Drain: CROOKED CREEK Drain #: 250
 Improvement/Arm: MAYFLOWER
 Operator: J. LIVINGSTON Date: 1-22-04
 Drain Classification: Urban/Rural Year Installed: 1974

GIS Drain Input Checklist

Re: Crooked Creek Drain: Mayflower Arm

MECHANICAL SITE PLANS

PROJECT NO. 03092
 DATE: MARCH 10, 1972
 OFFICE OF HAMILTON COUNTY SURVEYOR
 NO. M-1
 OF 30

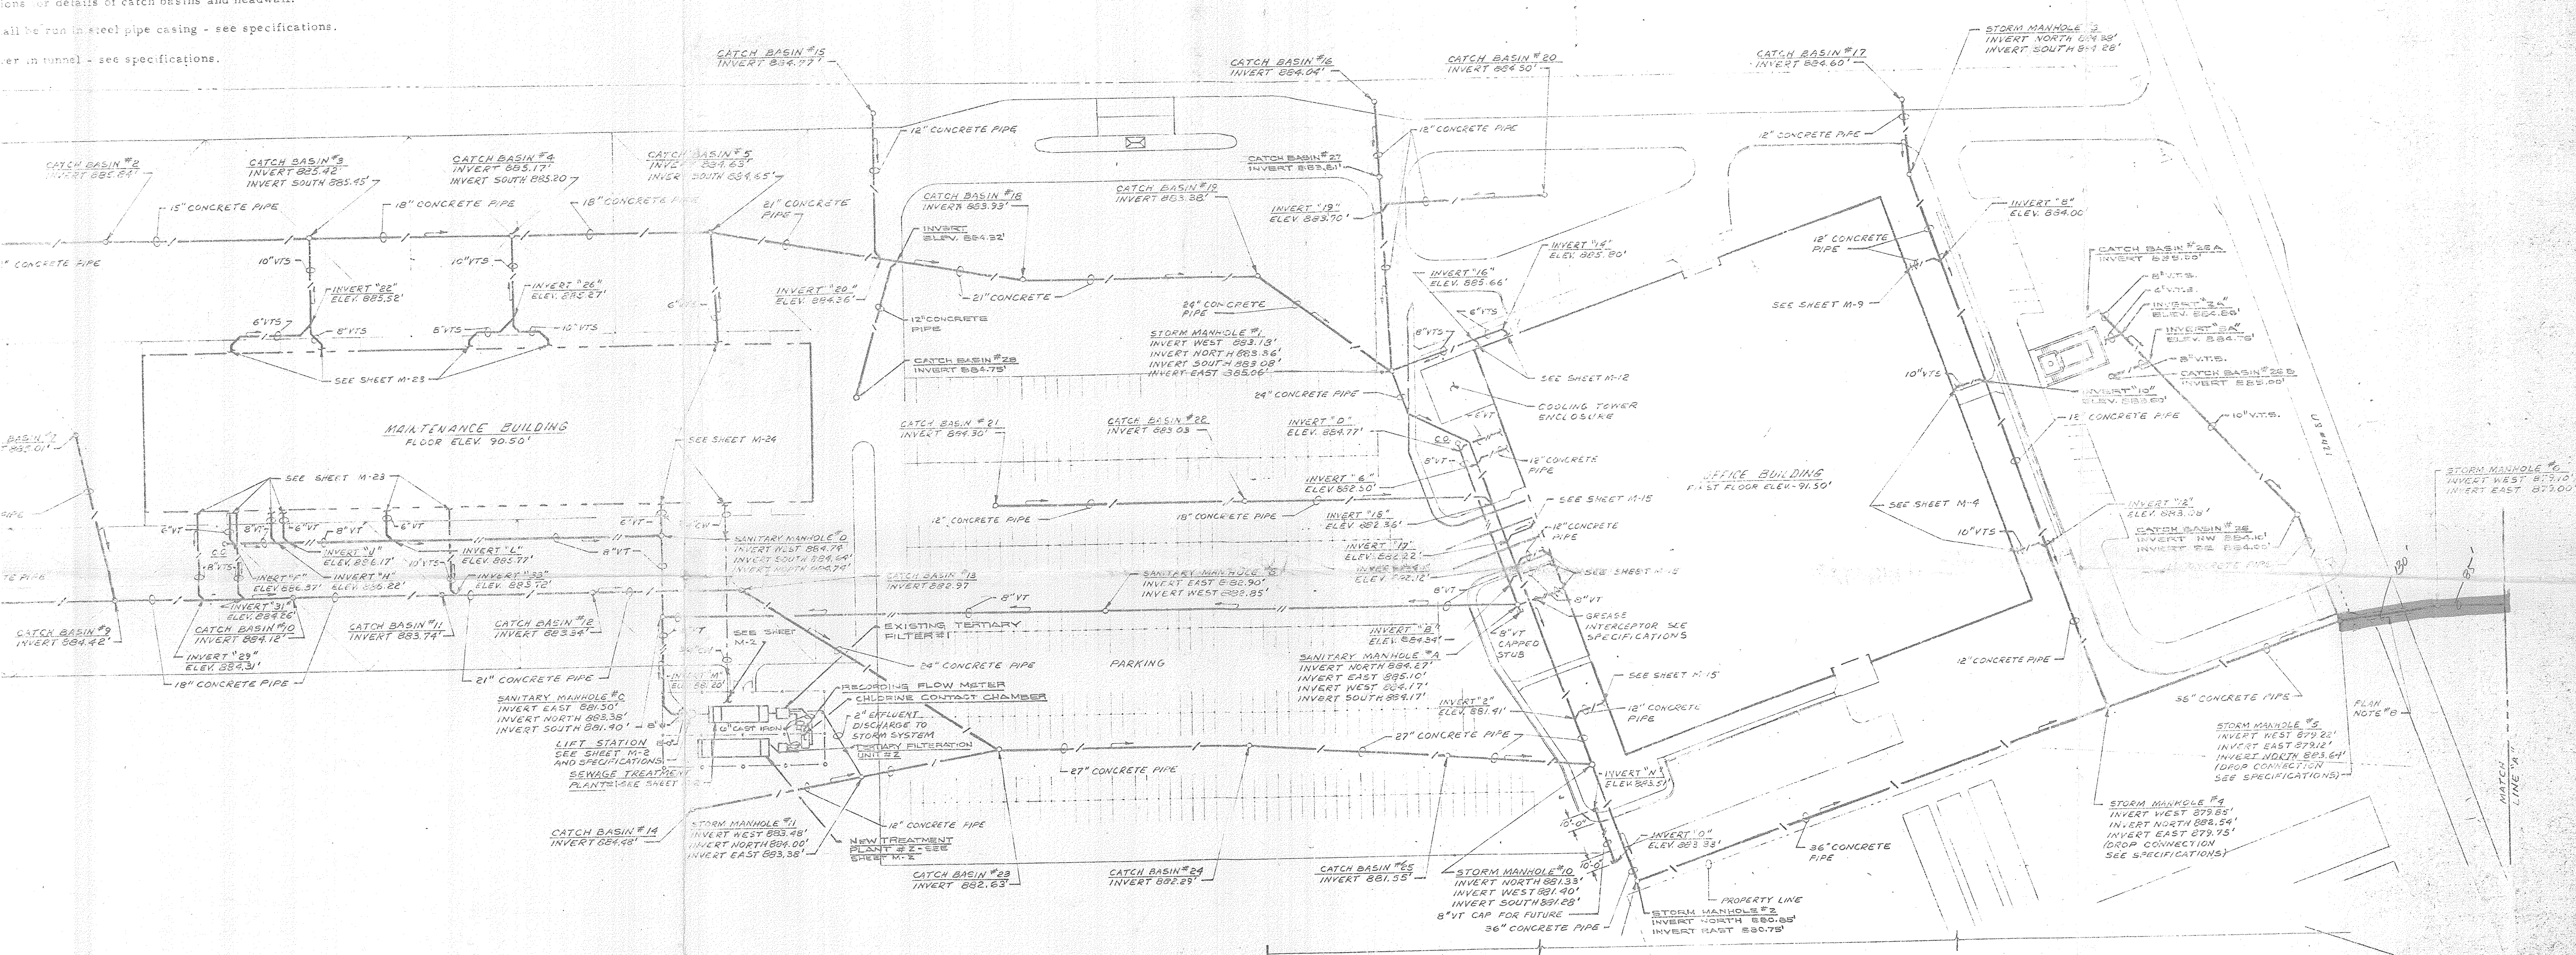
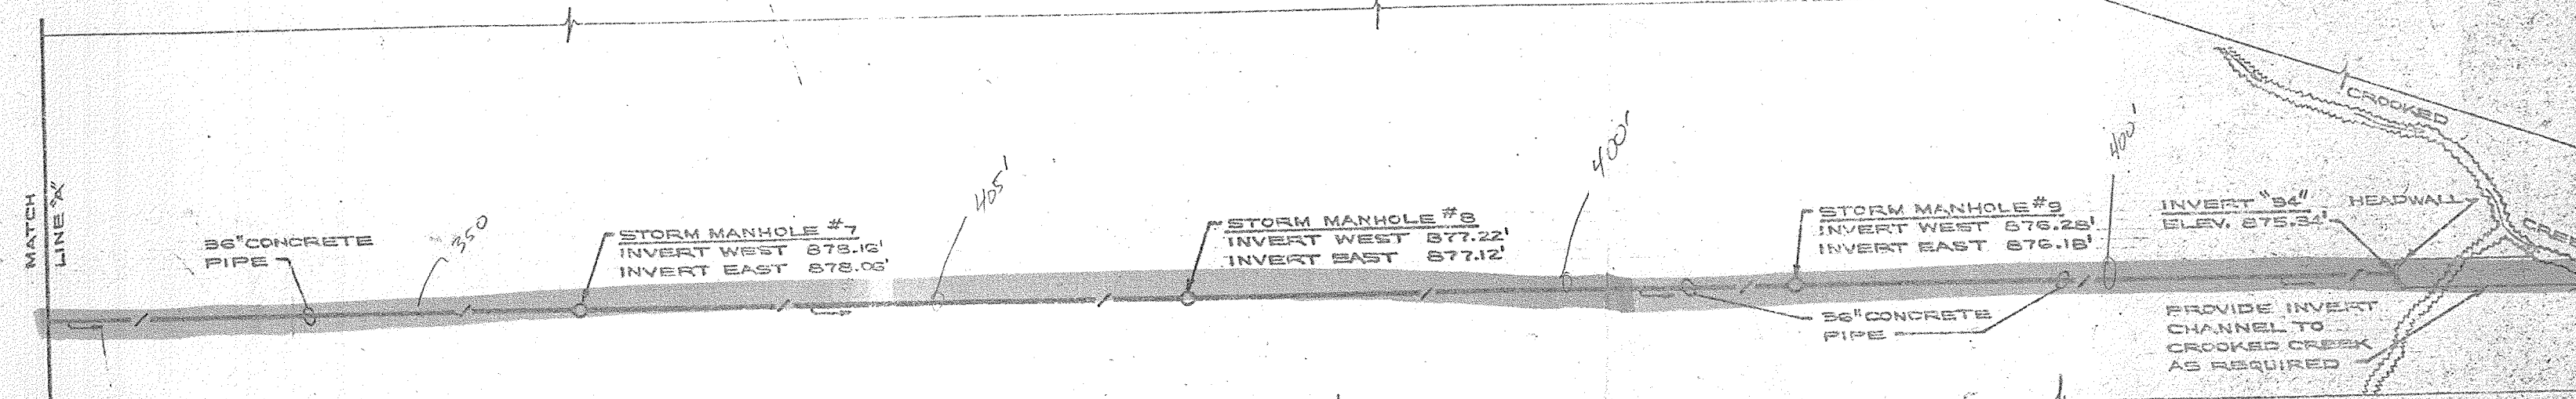
The 36" RCP was shortened from 1800 feet to 1770 feet. The open ditch was lengthened from 65' to 135'.

The total length of drain due to the changes described above is now **1905 feet**.
